UNITED STATES PATENT AND TRADEMARK OFFICE

APPLICATION NO.	FILING DATE	FIRST NAMED INVENTOR	ATTORNEY DOCKET NO.	CONFIRMATION NO.
10/553,383	10/19/2005	Taeyoung Park	TECHVIL-220	3659
24972 7590 07/14/2008 FULBRIGHT & JAWORSKI, LLP 666 FIFTH AVE NEW YORK, NY 10103-3198			EXAMINER KASTURE, DNYANESH G	
			ART UNIT 3746	PAPER NUMBER
			MAIL DATE 07/14/2008	DELIVERY MODE PAPER

Office Action Summary	Application No. 10/553,383	Applicant(s) PARK ET AL.	
	Examiner DNYANESH KASTURE	Art Unit 3746

DETAILED ACTION

Fig. 1

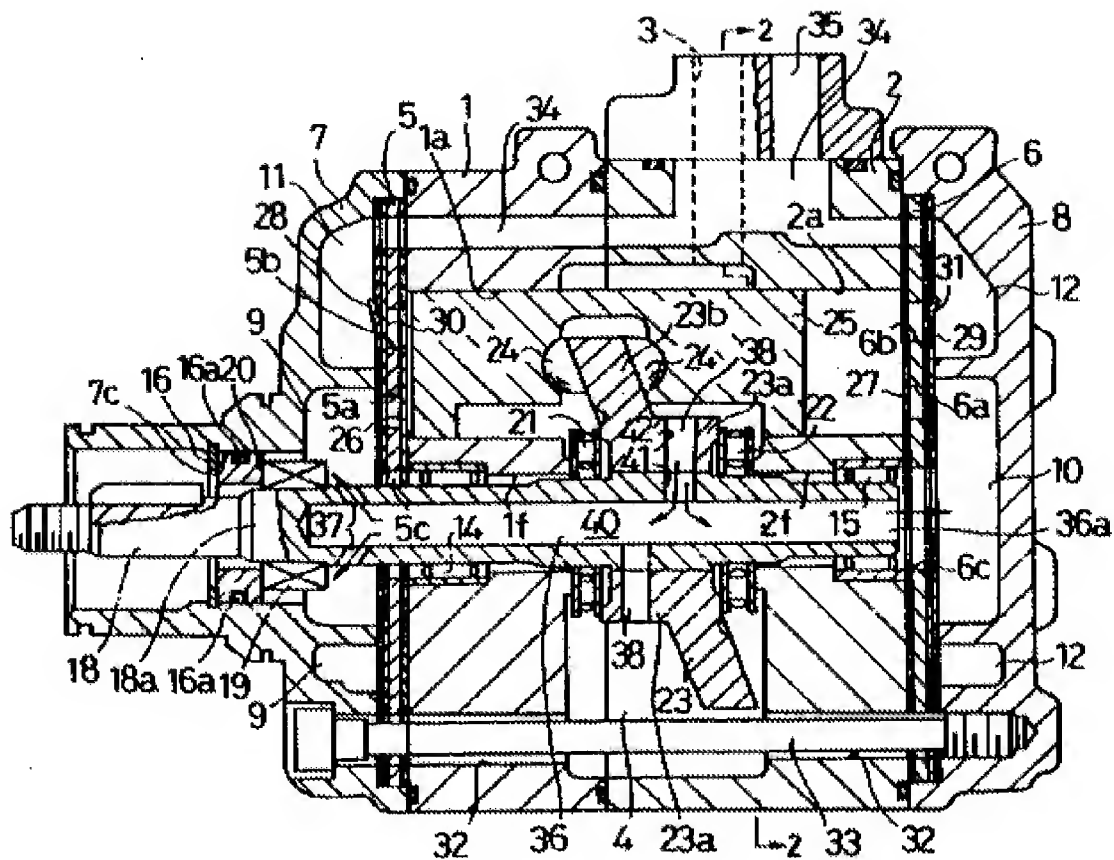
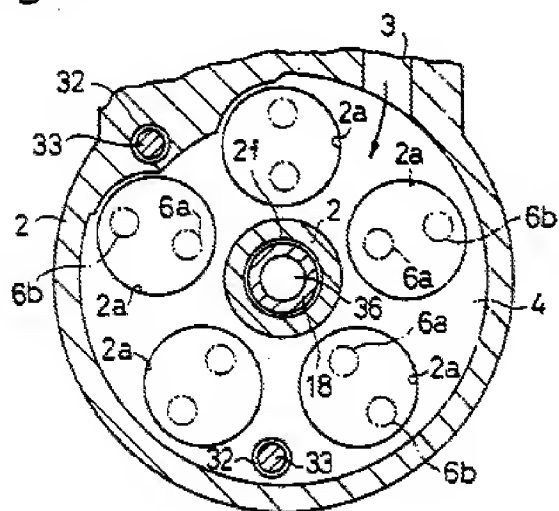
3. In Re claim 12, with reference to figures 1 and 2, Fujii et al discloses a compressor installed to one side of driving means (not depicted) that provide drive to shaft (18), the compressor unit comprises:

- a front housing (7) having discharge chamber (11)
- a rear housing (8) having a suction chamber (10) inherently partitioned from a discharge chamber (12), with a discharge port (35) formed at one side communicating through discharge passage (34) with the discharge chamber (12)
- a cylinder block (1), (2) coupled between the front housing (7) and the rear housing (8) and having a plurality of bores (1a), (2a) formed at both sides (1a) and (2a) of the swash plate chamber that is inherently formed within cylinder blocks (1), (2) and a refrigeration suction port (3) formed at one side thereof

- a swash plate (23) placed in the swash plate chamber and coupled with drive shaft (18), and a plurality of double head pistons (25) (Column 3, Line 25) for reciprocating within the bores (1a), (2a) in cooperation with the rotation of the swash plate (23)
- feeding passage (38), (40), and (36a) for feeding refrigerant from the swash plate chamber partially into the suction chamber of the rear housing (10). With regards to the amendment “..passage for feeding refrigerant..”, this limitation no longer invokes 35 USC 112 6th paragraph (that was invoked prior to the amendment).

9. In Re claim 15, Fujii et al discloses a passage (40) formed in the drive shaft (18), and inlet passages (38) communicating the swash plate chamber to the passage (40), to allow the flow of refrigerant from the swash plate chamber towards the passage (40).

10. In Re claims 16 and 17, Fujii et al discloses that the inlet passages (38), (40) are formed inside the drive shaft (18) and the hub (23a) and, the inlet passage (42) in the hub (23a) is coupled with the inlet passage (41) in the drive shaft (18).

11. In Re claim 18, Fujii et al discloses the discharge chamber (11) of the front housing (7) is communicated with the discharge chamber (12) of the rear housing (8) via a communication passageway (34) formed through the cylinder blocks (1) and (2).

Fig. 5

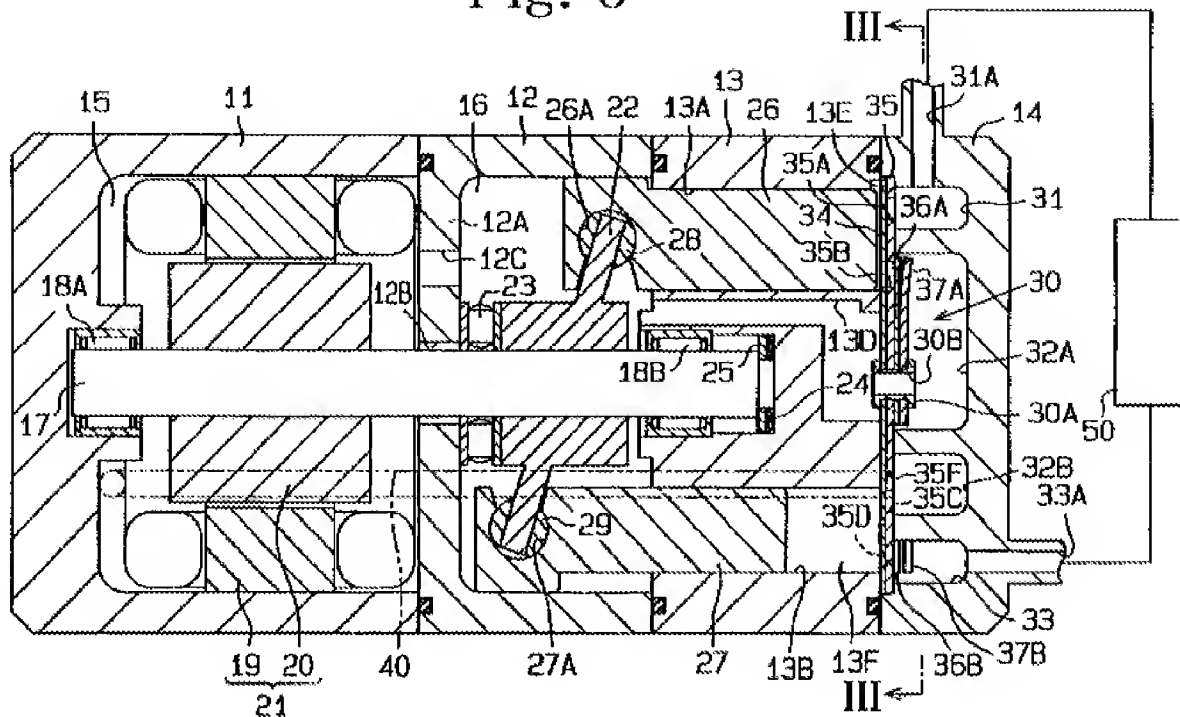
5. Nevertheless, with reference to Figure 5, Yokomachi et al discloses a motor driven compressor unit comprising:

- a motor unit (11) comprising an electric motor (21) installed in an inside motor room (15) for rotating a drive shaft (17)
- a compressor unit installed to the right of motor unit (11) as depicted, the compressor unit comprising:

- a front housing (12)
- a rear housing (14) having chamber (32B) inherently partitioned from a discharge chamber (33), with a discharge port (33A) formed at one side communicating with the discharge chamber (33)

- a cylinder block (13) coupled between the front housing (12) and the rear housing (14) and having a plurality of bores (13A), (13B) formed at both sides (13A) and (13B) of the swash plate chamber (16) and a refrigeration suction port (31A) formed at one side thereof

- a swash plate (22) placed in the swash plate chamber (16) and coupled with drive shaft (17), and a plurality of double head pistons (26), (27) for reciprocating within the bores (13A), (13B) in cooperation with the rotation of the swash plate (22)

- feeding means comprising communication bore (12C) and central bore (12B) for feeding refrigerant from the swash plate chamber (16) partially into the motor room (15). With regards to “..means for feeding refrigerant..”, this limitation meets the three prong test per MPEP 2181 and thereby invokes 35 USC 112 6th paragraph. The means for feeding refrigerant has been disclosed in Figure 5 of applicant's drawings.

- the front housing (12) further has a suction passage (40) for communicating the motor room (15) to the bore (13B) through intermediate pressure chamber (32B) to allow the suction of refrigerant supplied to the motor room (15) into the bore (13B). In addition, there is another suction passage communicating the bore (13A) to the motor room (15) originating at the bore (13A), through chamber (30), hole

(30B), communication bore (13D) and communication bore (12C) in the front housing (12) leading into the motor room (15).

Fig. 4

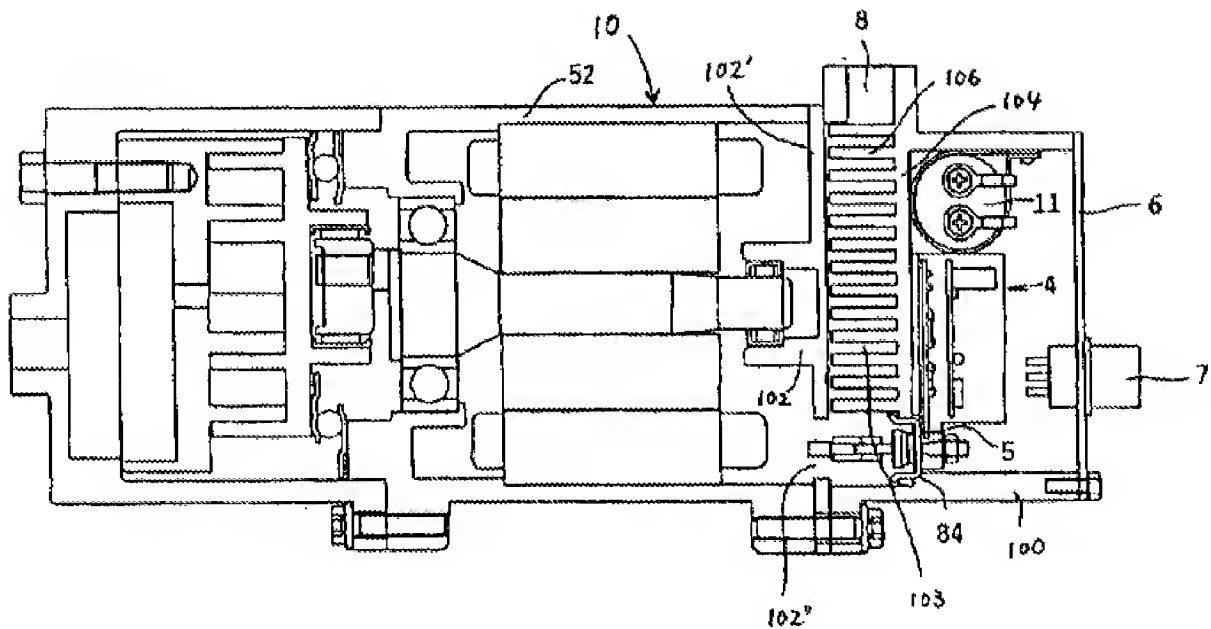
15. However, with reference to Figure 4 depicted above, Saito et al discloses a suction muffler chamber (100) formed at one side of cylinder block (52), the suction muffler chamber (100) is mounted with motor controlling means (4) on an upstream section (103) where refrigerant is introduced through inlet port (8).

17. In Re claim 21, Saito et al discloses the motor controlling means (4) comprises an inverter (2) as mentioned in Paragraph [0033].
